PROJECT: Large-scale Residential Development (LRD)

LOCATION: Junction of Swords Road & Santry Avenue,
Santry, Dublin 9.

REPORT: Statement of Response to Dublin City Council
LRD Opinion Ref. LRD 6044/23-S2.

CLIENT: DWYER NOLAN DEVELOPMENTS LTD.

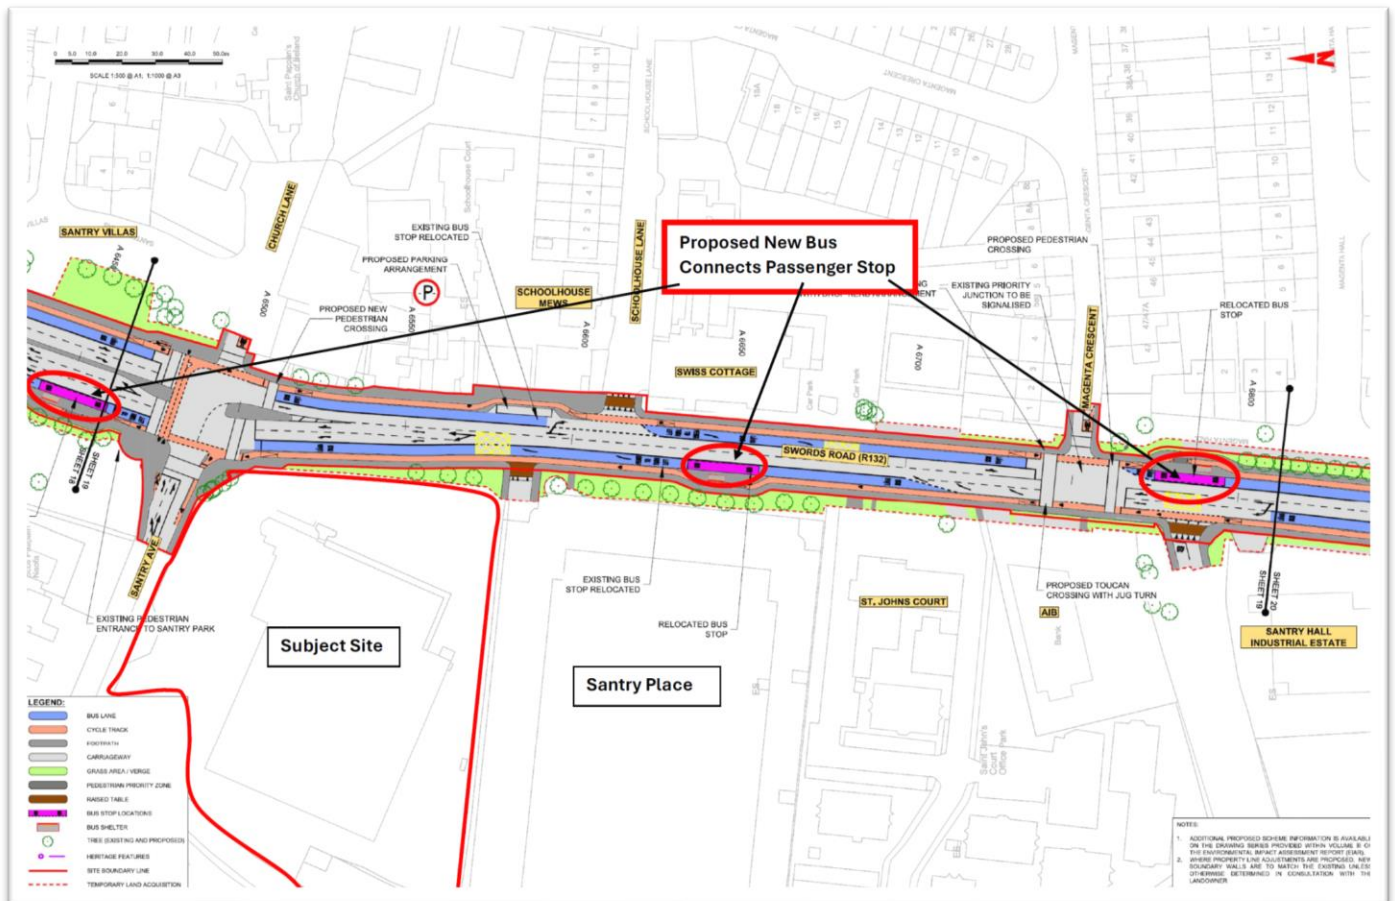
e. *The proposal is for 211 units per hectare, while the Development Plan sets the range for sites in the Outer Suburbs at 60-120 uph. A strong case needs to be made for the proposed density.*

The necessary definitions are provided in Table 3.8, including the term ‘High Capacity Public Transport Node or Interchange’, which is defined as including lands within 1500 metre walking distance of an existing or planned BusConnects ‘Core Bus Corridor’ stop. The proposed development site is within the Metropolitan Area of Dublin City, along a prominent public transport route into the city, within the existing built-up urban environs of Dublin. Swords Road, which abuts the subject site to the east, is an established entrance route into Dublin city centre from the north of city and caters for high frequency public transport i.e. the Swords Road QBC, while the proposed BusConnects Corridor is also planned along this route. The subject site has good, proximate access to a wide range of services, facilities, employment and education opportunities, and amenities, and therefore the scale and quantum of development proposed for the subject site achieves compact growth. The development provides for a density of c. 214 no. dwellings per hectare. It is considered that given the location of the site in close proximity to a number of surrounding services, including being located along a public transport corridor and having access to proximate public transport links, that the proposed density on site is appropriate in this instance, and accords with the guidance set out in the SCS Guidelines.

Figure 6: Proposed Shower/Changing Rooms at Retail Units at Blocks A and B

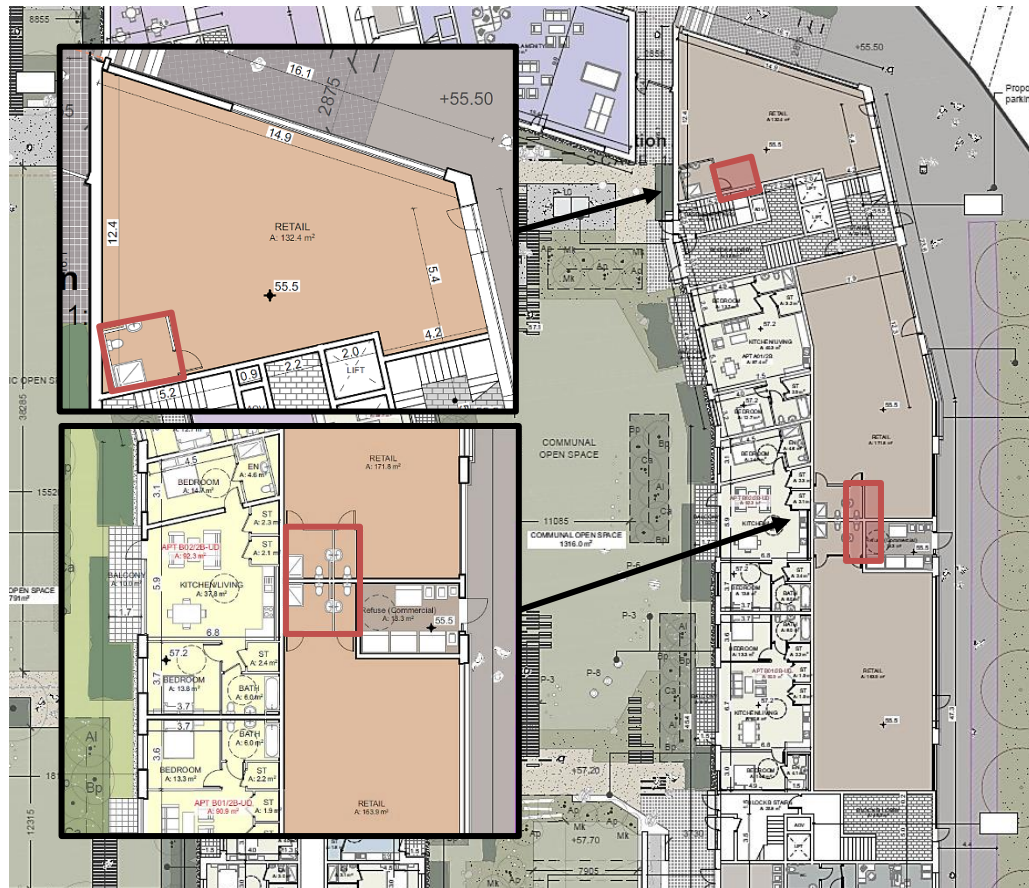
ii. Section 3.2 of Appendix 5 of the City Development Plan 2022-2028 outlines provisions for shower/changing facilities for employees of commercial developments. Applicant should clarify compliance where applicable and identity the locations of same for future employees of the non-residential elements of the development

The scheme now complies with Section 3.2 of Appendix 5 of the City Development Plan 2022-2028 in regard to the inclusion of suitable shower and changing for employees of the proposed retail units within the development. A total of three shower/changing rooms will be provided within the retail unit at ground floor level at Blocks A and B as illustrated in Figure 6 overleaf.
